CITY OF PORTLAND

Permit Number A064618 2005

City of Portland, Maine - Building or Use Permit Application

RE: Lot #11 Ballpark Drive - #371-A-041- R-2 Zone – application #05-0461

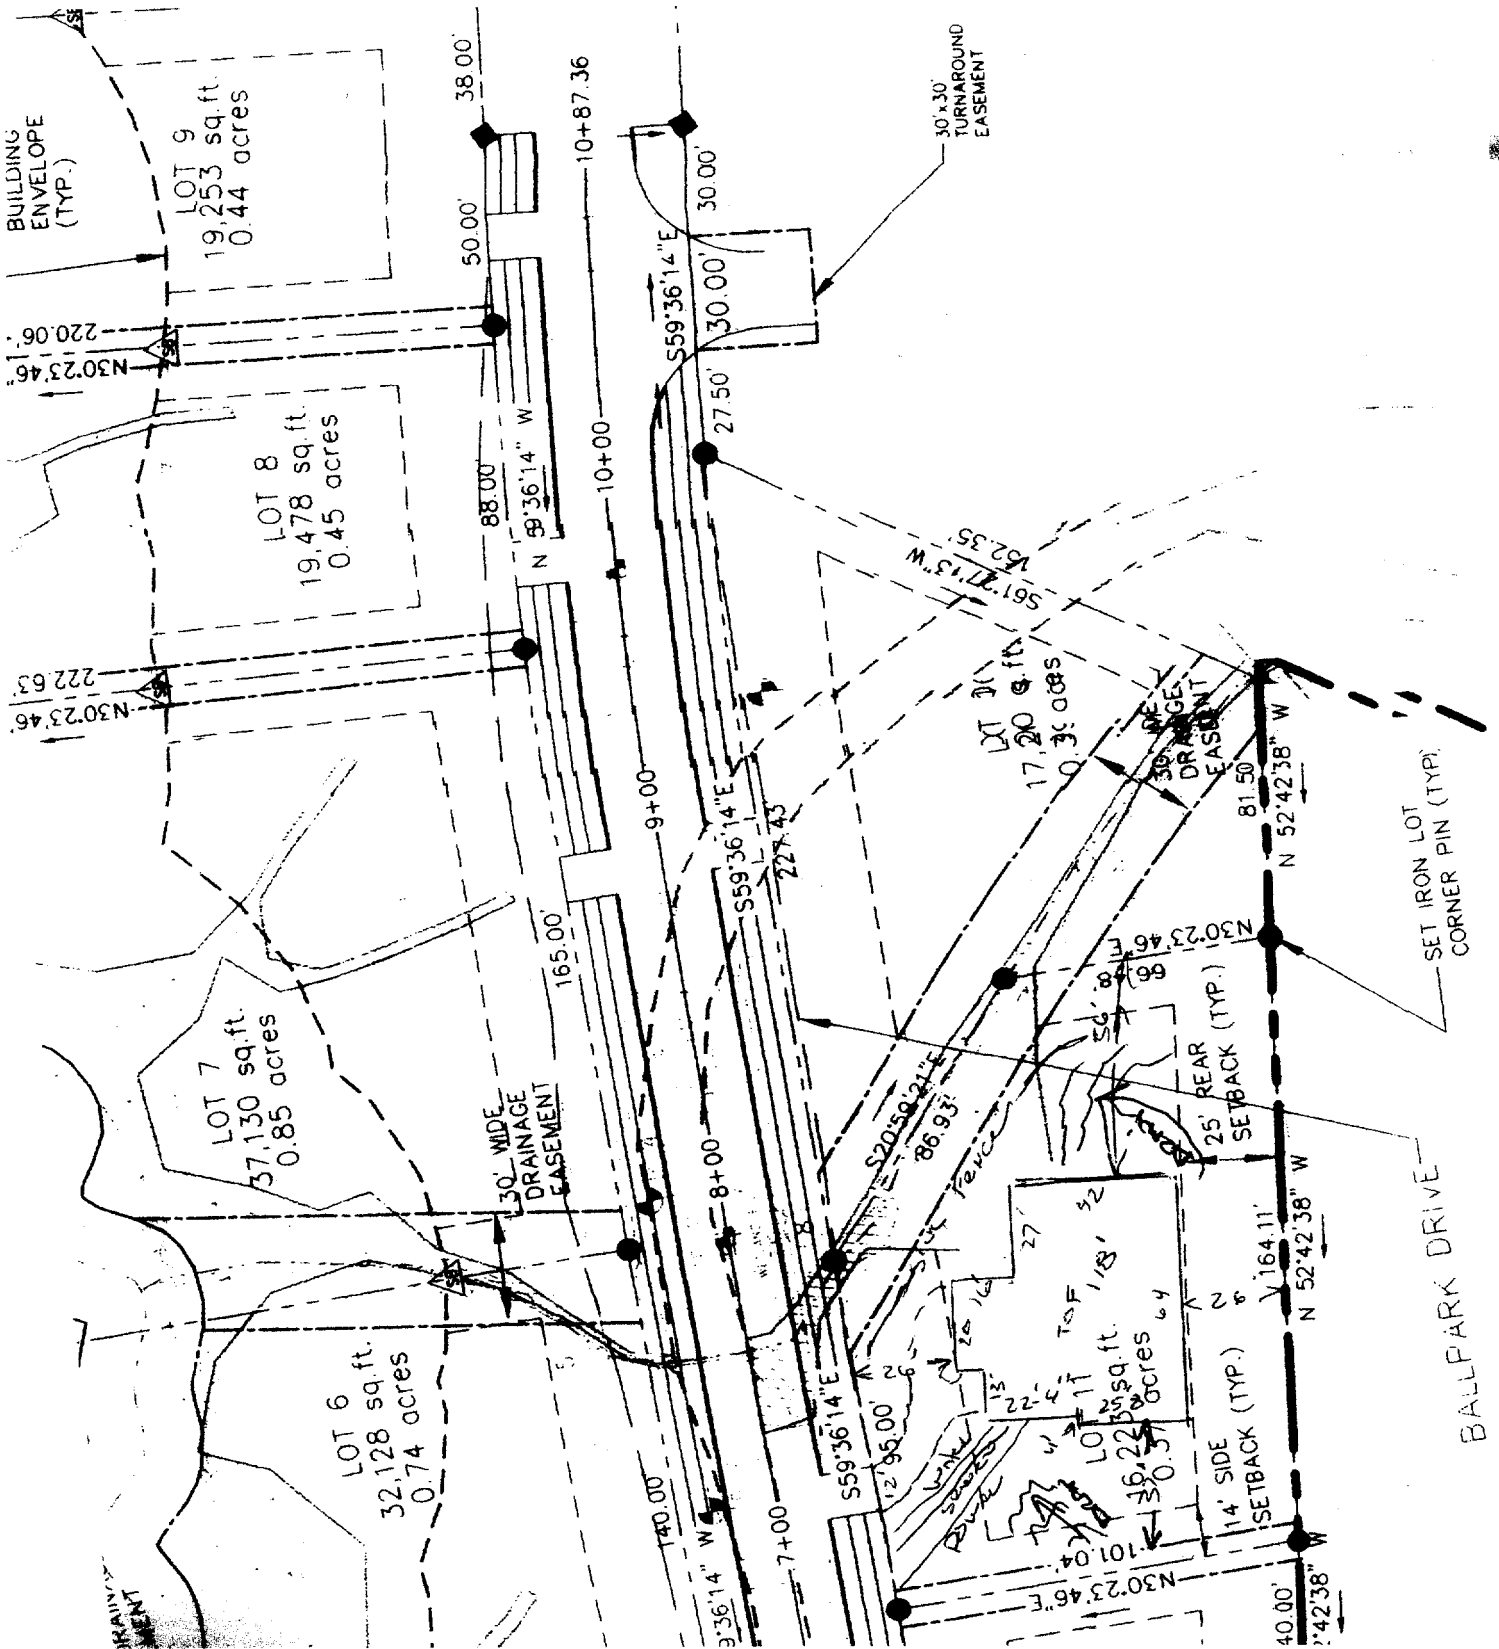
Marge, I haven't seen a corrective application from your office yet, I think I talked to Lannie or someone that a separate App. entry in urban insight needed to be created, and I think Lannie was going to do this when Doug Candage came back in with the \$300.00 app. fee and revisions. I did receive a site plan originally, which I rejected, and you based your letter on.....Jay

Jay,
Did you ever get a minor/minor site plan for lot #11 Ballpark Drive? I don't see anything in the system. I wrote them a letter saying that they needed to submit site plans (which they just did) and pay for a site plan review. But I am not seeing that they ever applied for a site plan review.
Thanks,
Marge
